| This ASB revises ASB-912-061 dated 26 May 2012

ALERT SERVICE BULLETIN

Replacement of the pressure side fuel hose at fuel pump part no. 893114 for ROTAX® Engine Type 912 (Series)

ATA System: 73-00-00 Fuel system

Fig. 1
Fuel pump

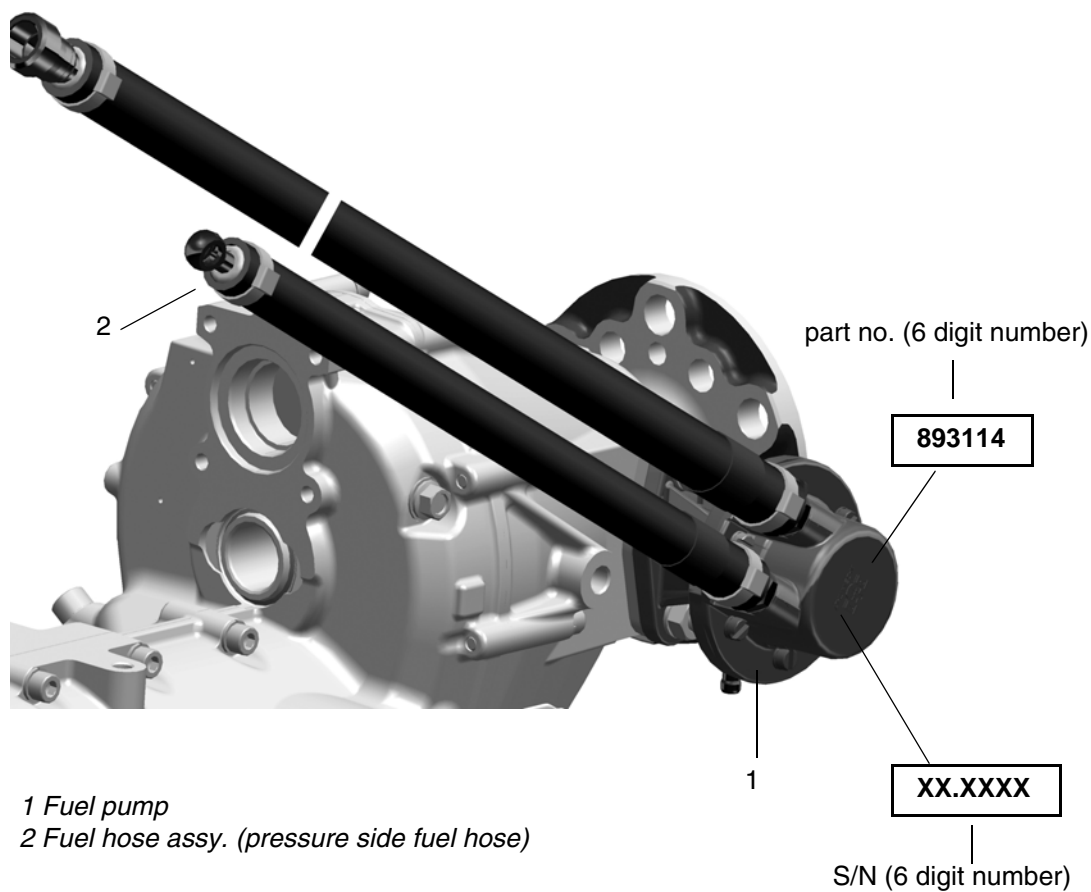
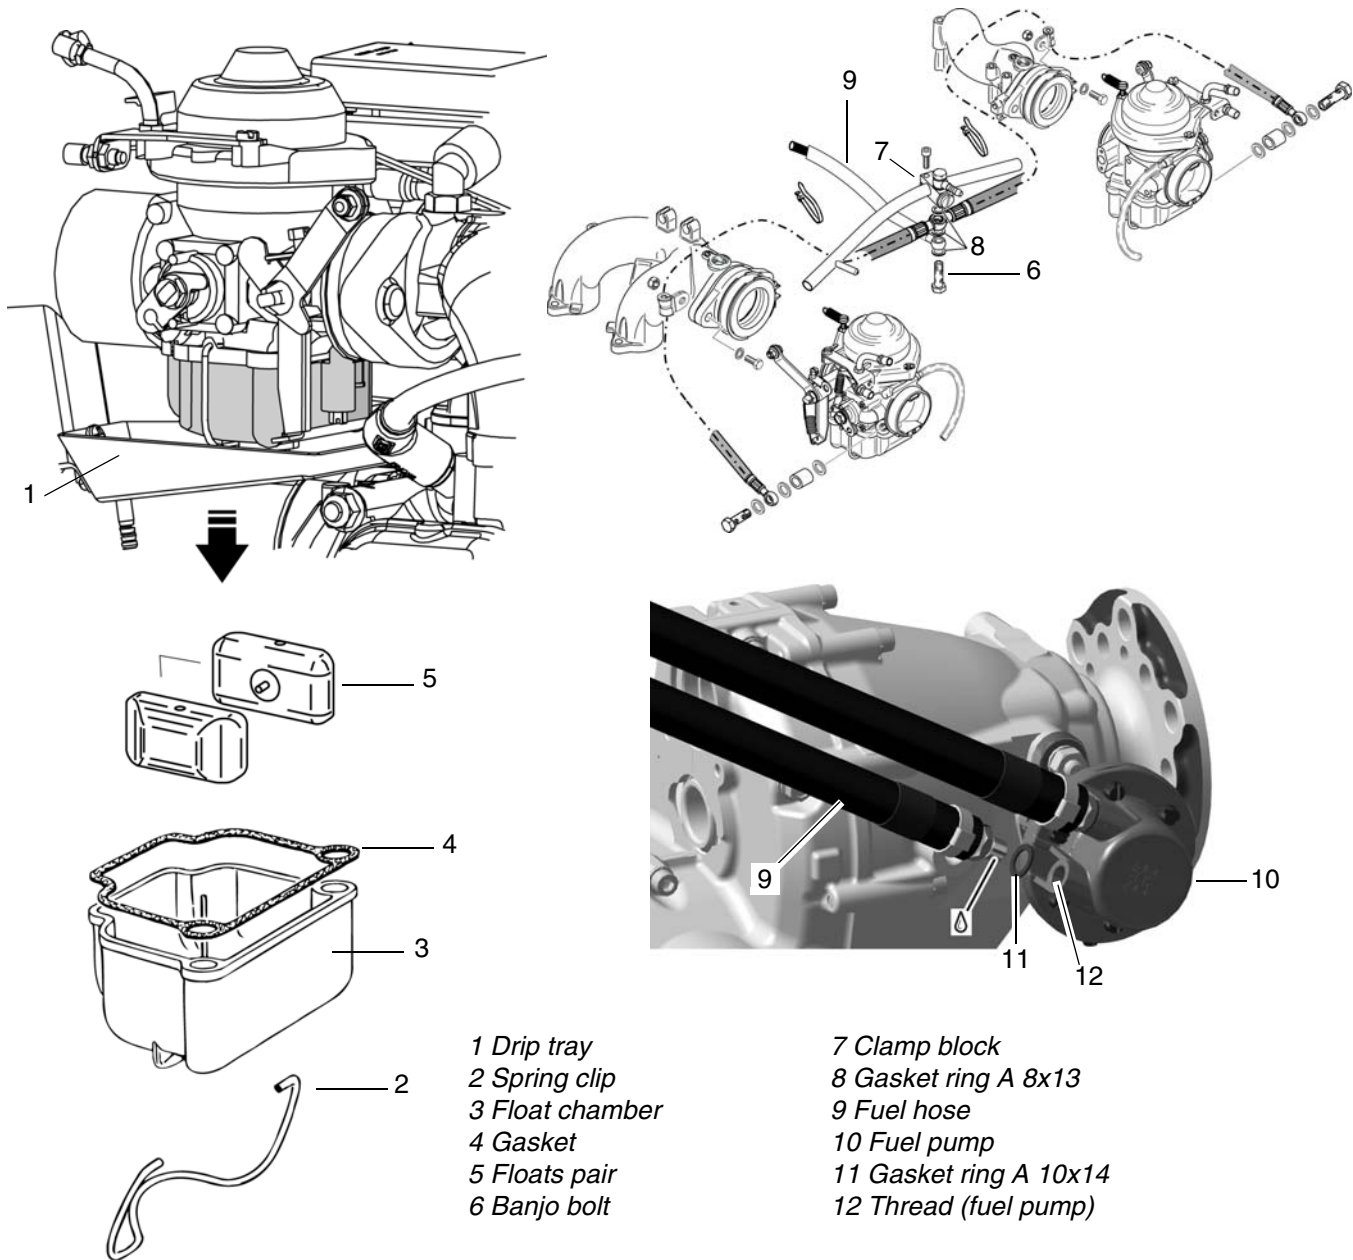
if they are equipped with the genuine ROTAX® fuel pump part no. 893114.
See [Fig. 1](#)

Due to variations in the manufacturing of the fuel hose, rubber particles may become detached. These particles can interfere or suppress the fuel mixture in the carburetor. This disturbance in the fuel mixture may lead to rough engine operation, engine misfire and can cause an engine shut down.

- **Required before the next flight, the “replacement of the pressure side fuel hose“ identified by the engine or fuel pump serial number (S/N) listed in section 1.1) must be conducted according to the following instructions in section 3.**
